Staff Review Transmittal

Weber County Planning Division

Application Request: Shaye Estates
Applicant: Carly & Brayden Thomas
File Number: LVS121814

SHAYE ESTATES
PART OF THE NORTHEAST QUARTER OF SECTION 16,
TOWNSHIP 6 NORTH, RANGE 2 WEST,
SALT LAKE BASE AND MERIDIAN
WEBER COUNTY, UTAH, DECEMBER 2014

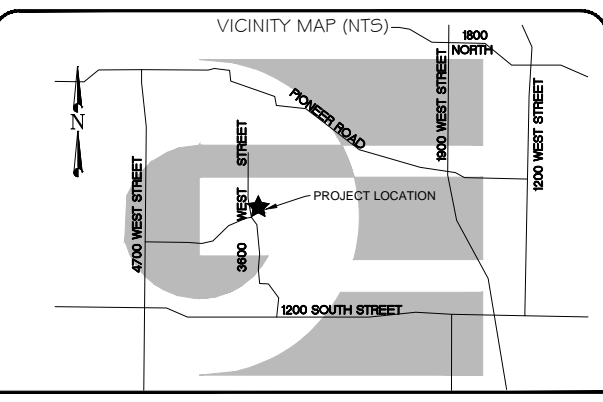
* Per the County Engineering Division, please add a note on the plat requiring the construction of the lowest habitable floor to be at or one foot above the existing pavement surface of the road.
 * Per the County Engineering Division, please add a note on the plat stating "No Basements Permitted" for Lot 2.

* Please identify the location of all percolation test holes on lot 2

* 174 South 3600 West

* Please identify the existing location of the sanitary sewer on Lot 1

* According to aerial photos, there are multiple out buildings on the site and on the parcel directly south of the proposed subdivision. Please identify all structures in and within 30' of the proposed subdivision including the distance to the closest property line to ensure adequate setbacks have been met.

* The title report does not match the proposed subdivision boundary. Please provide a title report that matches the proposed subdivision boundary.

* please add ", trustee of the CSB Trust Dated January 15, 2013" to the notary acknowledgment
